# TECHNICAL REPORT

Design changes in cylinder  
head gasket 10190900 of  
Toyota engines 1ZR/2ZR/3ZR

10180300 vs 10190900

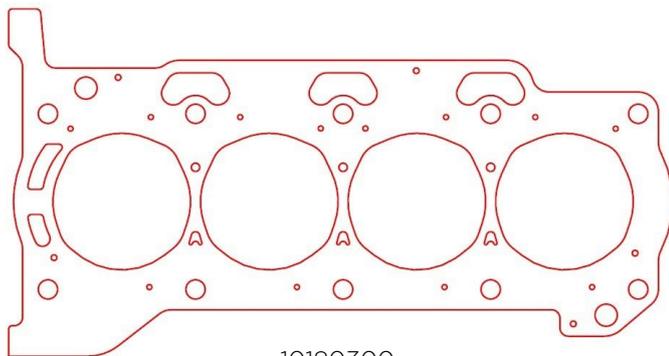
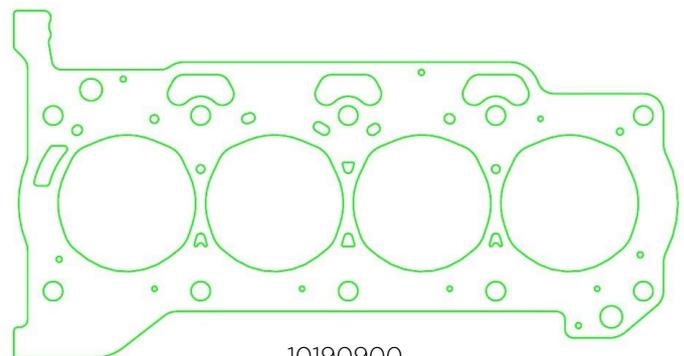
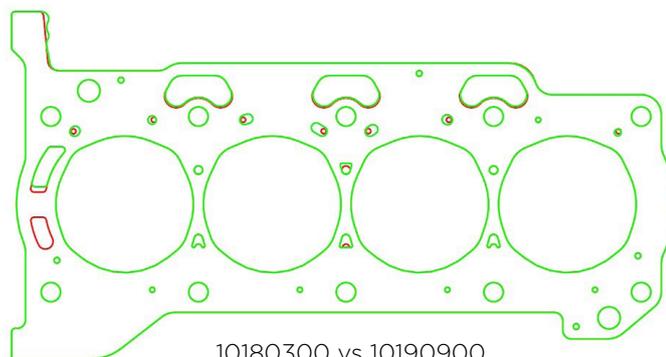
OEM design sometimes **changes the size and coolant holes shape** in order to make them more effective. Increasing their size in areas away from the coolant pump and decreasing, or even removing, those coolant holes from areas close to the pump.

As you can see, there are **some changes in the coolant holes** between both cylinder head gaskets.

If you **find the old design** during a replacement process, it is mandatory to **replace it for the new design**, 10190900.
